RE: Comments on the Draft Bay Delta Conservation Plan and DEIS/DEIR

On behalf of Defenders of Wildlife, the Natural Resources Defense Council, and the Bay Institute, and our combined membership and activists, we are writing to submit comments on the draft Bay Delta Conservation Plan (“Draft Plan”) and associated Draft Environmental Impact Report and Draft Environmental Impact Statement (“DEIS/DEIR”).

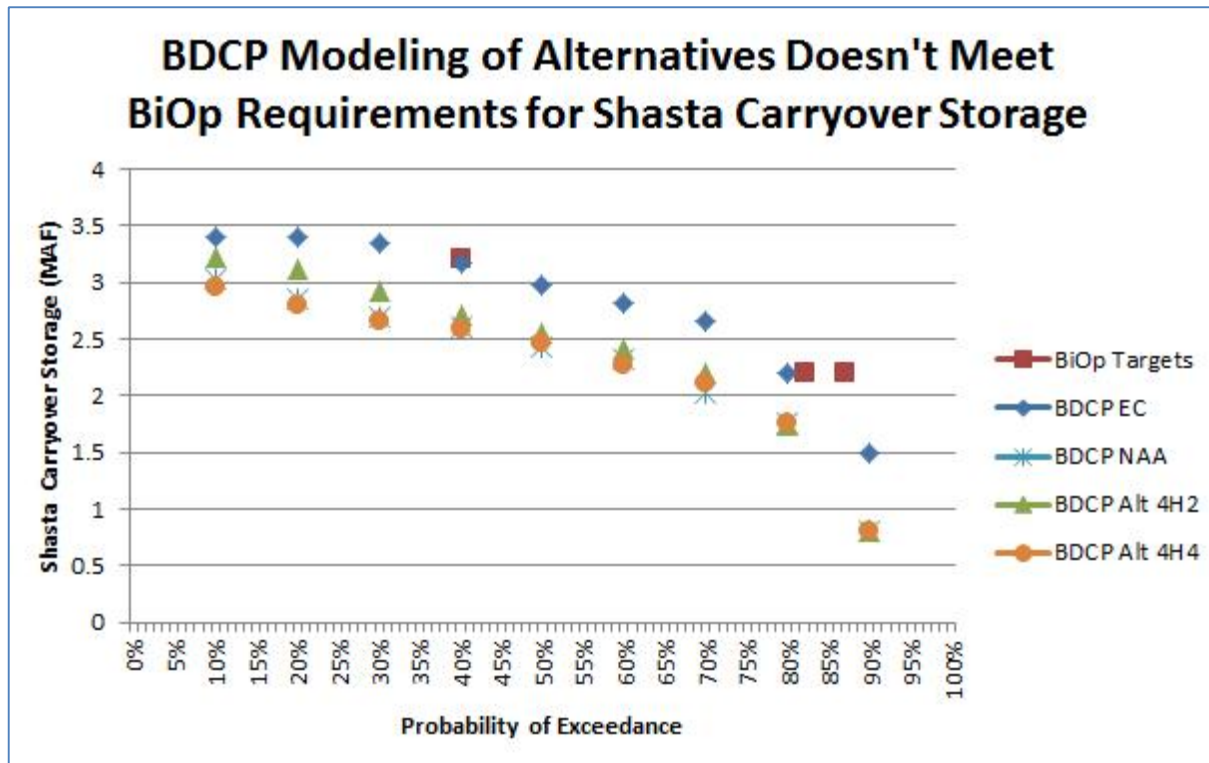
- If the intent is that exceedances will be minimized, but real differences in EC compliance exist between the alternatives, then the anomalies should be better-characterized so that only the real differences between the alternatives are presented. The way the results are presented combined with the disclaimer, the analysis is not useful, and does not enable a decision maker or the public to answer any of the questions posed above.

The DEIS/DEIR states that, "If necessary, comparisons of model results against threshold or standard values should be limited to comparisons based on cumulative probability distributions." DEIS/DEIR Appendix 5A, Section C, at C6. Yet the exceedance of a standard should result in probabilities close to zero, and the lack of such output indicates that the models are inaccurate.

intention" of meeting D-1641 standards. This does not seem to be the case in certain dry years such as 2013 and 2014, and the effects of similar relaxations of water quality standards and other environmental requirements in the future are not analyzed or disclosed in the DEIS/DEIR, despite the fact that such changes are reasonably foreseeable. According to the 2014 independent panel review of delta outflow and other stressors, "The average measured Delta outflow during fall 2013 was approximately 2,000 cfs, which failed to meet the Board's minimum outflow requirement of 3,000 to 3,500 cfs for fall months of a critically dry year." DSP Outflows Review Panel Report 2014 at 15. Likely future waivers and relaxations of standards modeled in BDCP are yet another example of how the modeling of BDCP fails to accurately assess likely environmental impacts.
